PRODUCT CHANGE NOTICE

PCN #17-005

**M3SWA-2-50DR+, SWMA-2-50DR+, YSWA-2-50DR+ (and YSWA-2-50DR)
M3SW-2-50DR+, SWM-2-50DR+, YSW-2-50DR+ (and YSW-2-50DR)**

M3SWA-2-50DRA+

Figure 1. Block Diagram of test Circuit used for characterization (DUT soldered on Mini-Circuit's TB-159A+)

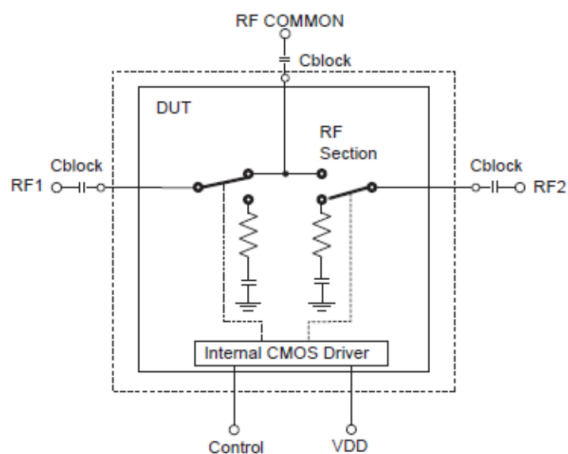
- Discontinuation of model series and replacement by **M3SWA-2-50DRA+** (see spec sheet below on pg.3)
- See Replacement Guide and Web Datasheet for performance and specifications
- Reflective models to use Absorptive version
NOTE: Replacement part requires use of external blocking capacitors
- Discontinuation of Non-RoHS version of YSW/YSWA

- Discontinuation of original die.
- Alternate qualified die requires customer circuit to include blocking capacitors.
- Discontinuation of non-RoHS YSW/YSWA for industry demand

1. Tested on Mini-Circuits' test board TB-159+, using Agilent's N5230A network analyzer (see Characterization test circuit, Fig.1).
2. Insertion loss values are de-embedded from test board loss.
3. Needs external blocking capacitors on all RF ports. (Suggested value=47pF)

Frequency (MHz)	Cblock (Suggested Value)
0.3-500	0.1 μ F
500-4500	47 pF
